## TECHNICAL NOTE

2020s1712  
Review of Drainage Strategy for Thames  
Farm, Shiplake  
Shiplake Parish Council  
12/03/2021  
Paul Eccleston

Review of Flood Risk Appraisal and  
Drainage Study

**Figure 2-1: Surface water flow pathways and site layout**

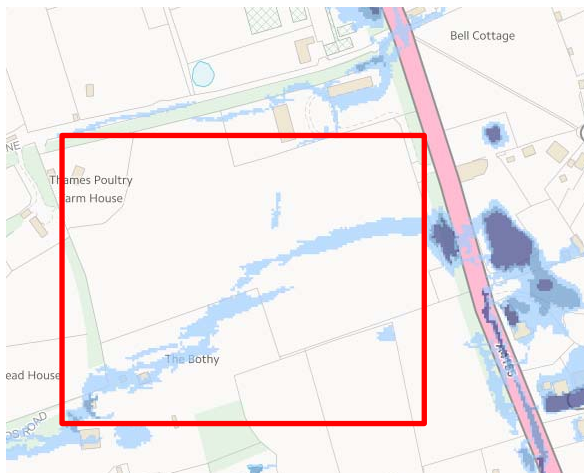
This is not actually the case, since the report (section 3) goes on to consider baseline flood risk to the site, including an improved assessment of surface water flow pathways across the site (two pathways are identified, whereas the 2016 FRA only identified one). As such, the study is improving the assessment of flood risk to the site but, because it does not seek to replace the FRA, makes no recommendations as to how these flow pathways should be managed. The site layout shown in the 2020 Drainage Strategy shows that properties are designed within the flow paths (see Figure 2-1). This indicates a lack of sequential planning within the site (a requirement of National Planning Policy Guidance) and designing for exceedance (a good-practice approach to drainage design recommended in the SuDS Manual<sup>6</sup>).

- The southern surface water flow pathway onto the site (shown in Figure 2-1) has the potential to bring in runoff from outside of the site and subsequently for this water to enter the site's drainage system. No allowance for such runoff has been made, and as discussed in section 2.1, the layout of the site has not been planned to allow for this flow pathway.

**Figure 3-1: Source Protection Zones**

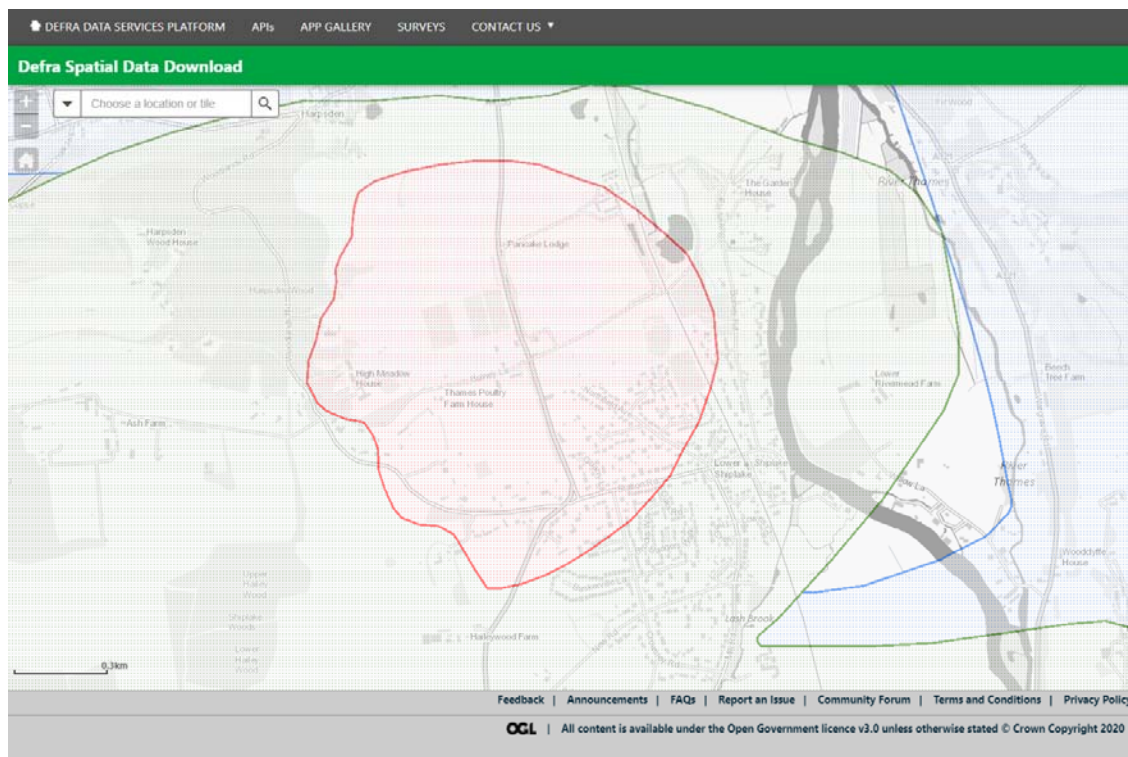
It is acknowledged that deep borehole soakaways would not be permitted as the site is in SPZ1, and that infiltration features close to buildings have the potential to encourage the formation of voids, preventing the use of shallow infiltration features close to buildings. However, this would not necessarily preclude the use of shallow infiltration features set further from buildings. It is probable that the developer has not considered this option because it would mean reducing the number of dwellings on the site in order to make space for adequate infiltration features.

We have noted above that the option of changing the development intensity in order to make space for discharge to ground using shallow infiltration features has not been considered. It is worth also noting that discharge to a deep borehole soakaway off the site has also not been considered. In theory water could be discharged to a deep borehole soakaway outside of Source Protection Zone 1 as shown by the red area in Figure 3-2. Such an option could result in a shorter length of pipework, and would be in line with the discharge hierarchy, however we acknowledge that such an option is

not without difficulties, and would likely require a landowner to be willing to sell or long-term lease a suitable plot of land to locate the soakaway.

**Figure 3-2: Comparison of newly modelled and existing flood outlines**

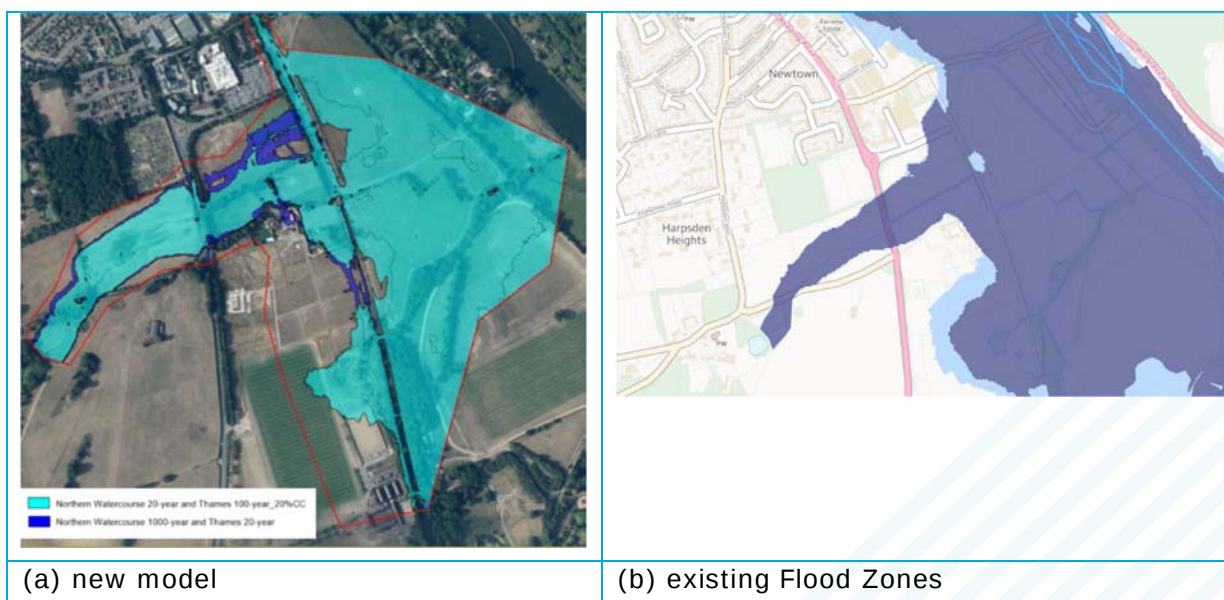
- The new flood outlines are broadly similar to the existing Flood Zones. The main differences appear to be due to the use of more detailed LiDAR terrain data available to the 2021 study (see Figure 3-2).
